CONSUMERS POWER COMPANY  
General Offices - Jackson, Michigan

Transmitted herewith are three (3) executed and nineteen (19) conformed copies of a request for a change to the Technical Specifications of License DPR-6, Docket No. 50-155, issued to Consumers Power Company on May 1, 1964, for the Big Rock Point Nuclear Plant.

Request for Change to the Technical Specifications

License No. DPR-6

FIGURE 2

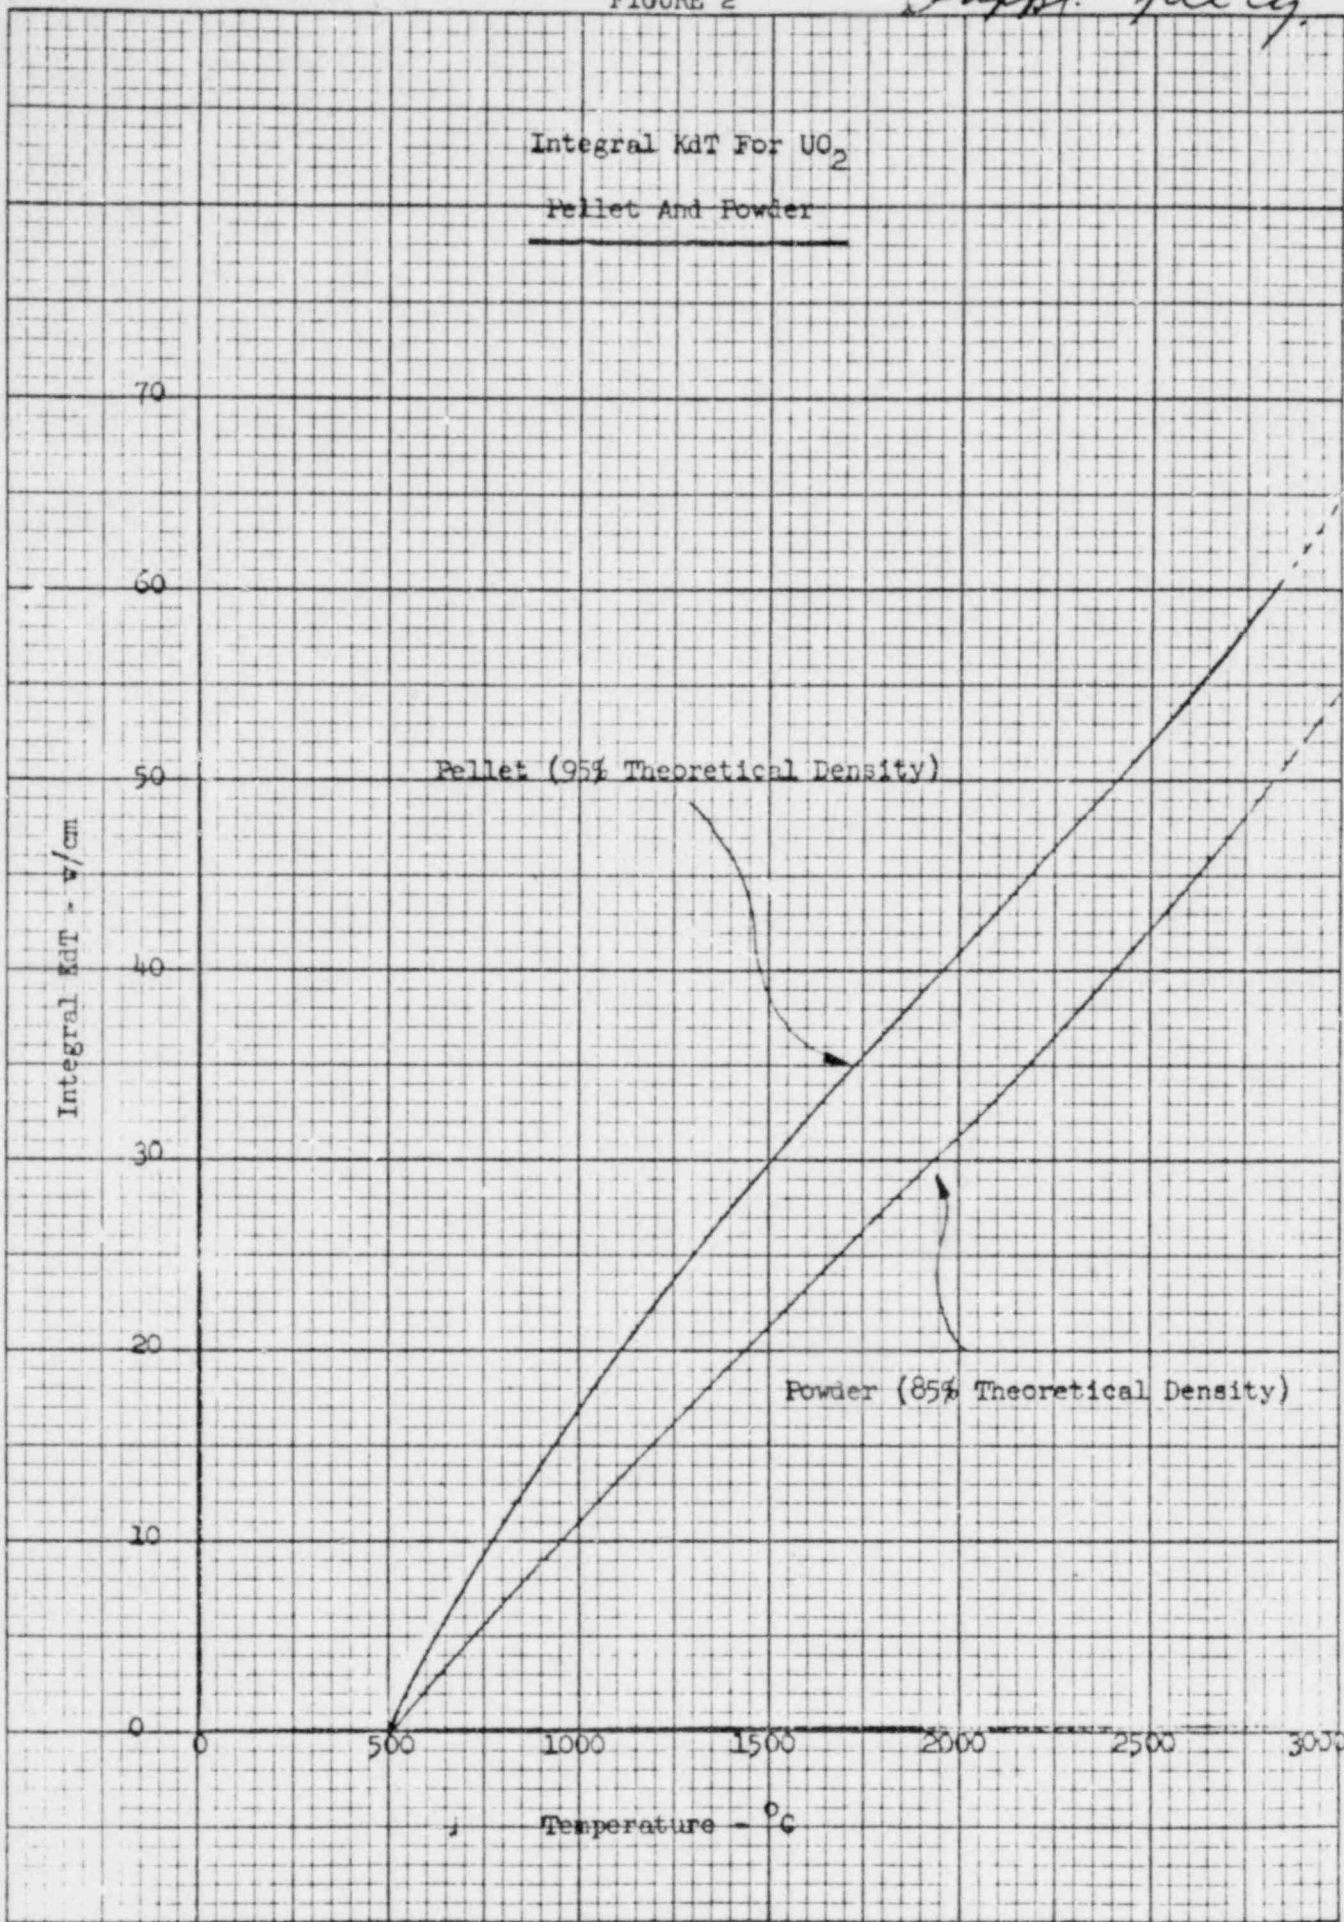
The thermal conductivity data and the heat transfer coefficient between fuel and clad for the "C" powder fuel are the same as previously described for ten pilot bundles included in the Type III-f reload fuel for Cycle 4 in the Dresden Nuclear Power Station. The previous thermal data were obtained from irradiations performed under the High Performance  $UO_2$  Program sponsored by the Joint U.S.-Euratom Research and Development Program. The  $UO_2$  powder conductivity data, as submitted for the Dresden reload pilot bundles, yield an integral  $KdT$  from the fuel surface temperature ( $500^\circ C$  by definition) to the melting temperature ( $2800^\circ C$ ) of  $49 \text{ w/cm}$ . (This was reported as preliminary data in the Dresden submittal.) In the summary report of the High Performance Program (GEAP-5100-1, " $UO_2$  Powder and Pellet Thermal Conductivity During Irradiation," by M. F. Lyons, et al, March 1966), the value of the integral as used for the Dresden powder bundles was confirmed. Based on post-irradiation analysis, Lyons, et al, recommended an integral value from surface to melt (as defined above)  $\approx 49 \text{ w/cm}$ . (See Figure 2.)

FIGURE 3

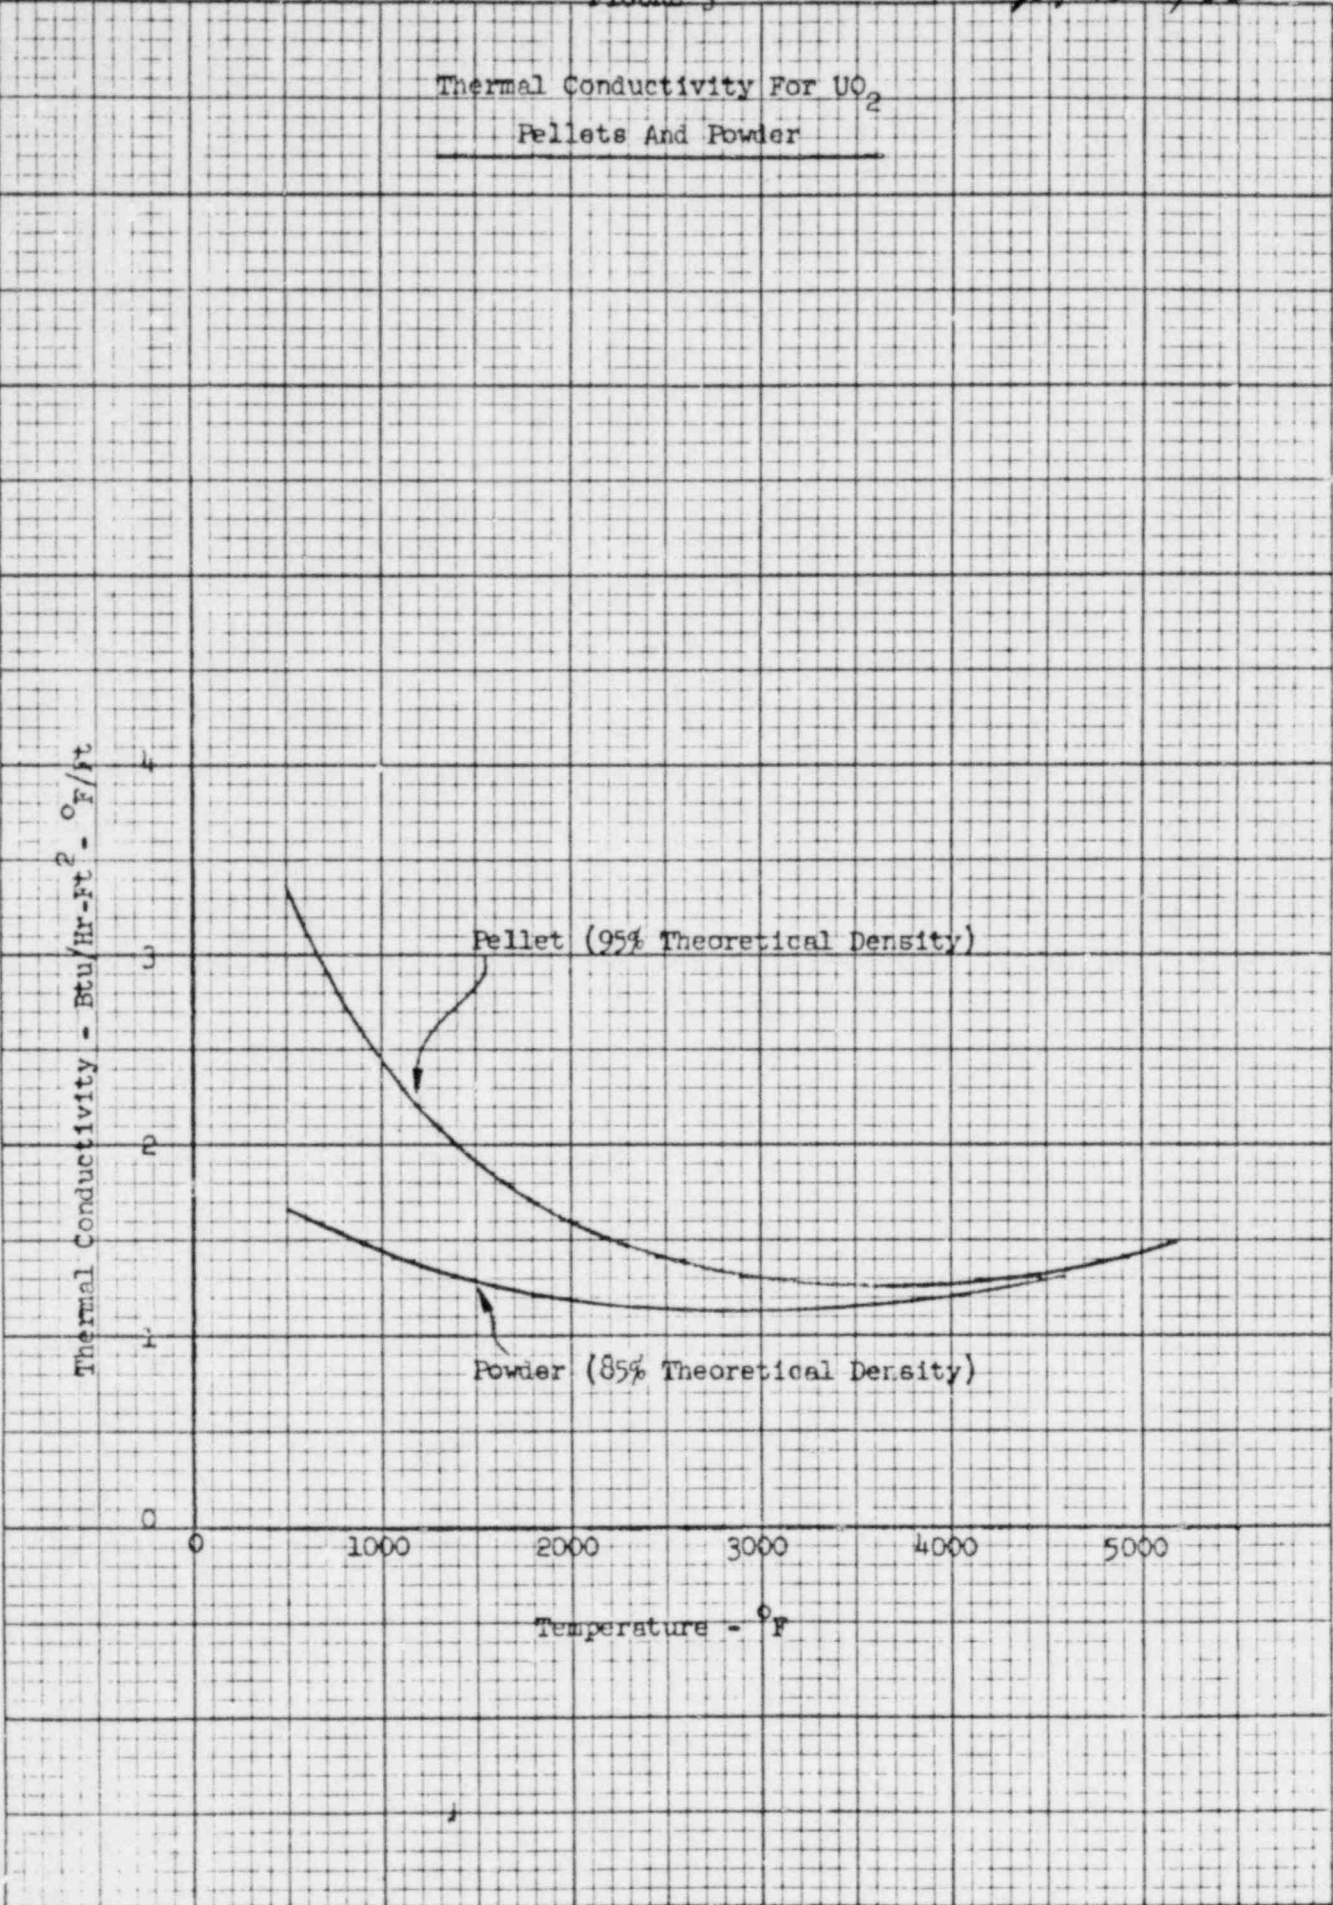
The establishment of an appropriate thermal conductivity curve for powder  $UO_2$  is a deduction from this. The approach used to establish the working curve for the Dresden and Big Rock Point powder fuel is based on the following line of reasoning. During the first few minutes of operation, the powder conductivity will be uncertain and probably change rapidly due to sintering of powder above the  $UO_2$  sintering temperature ( $\approx 1600^\circ C$ ) and densification. However, as these processes continue, the conductivity of the fuel above the temperature for the onset of grain growth will become very close to that determined earlier for pellets. The remaining differences in conductivity and in the conductivity integral values from surface to melting between powder and pellets are attributable to the poorer conductivity of the unsintered powder rim

operating below the grain growth temperatures. Working backwards from the previously established pellet  $\text{UO}_2$  conductivity curve, the powder conductivity was assumed to be identical, at the melting point temperature, to that for pellets. Below this temperature, the powder curve was assumed to gradually and smoothly fall below that for pellets. The deviation between the two curves was adjusted so that, upon reaching reasonable value for the surface temperature ( $\sim 500^\circ \text{C}$ ), the difference in area under the two curves equals the difference in the integral values from surface to melting. Below this temperature, the curve was simply extended smoothly to provide a reasonable mean through the out-of-pile data. (See Figure 3.)
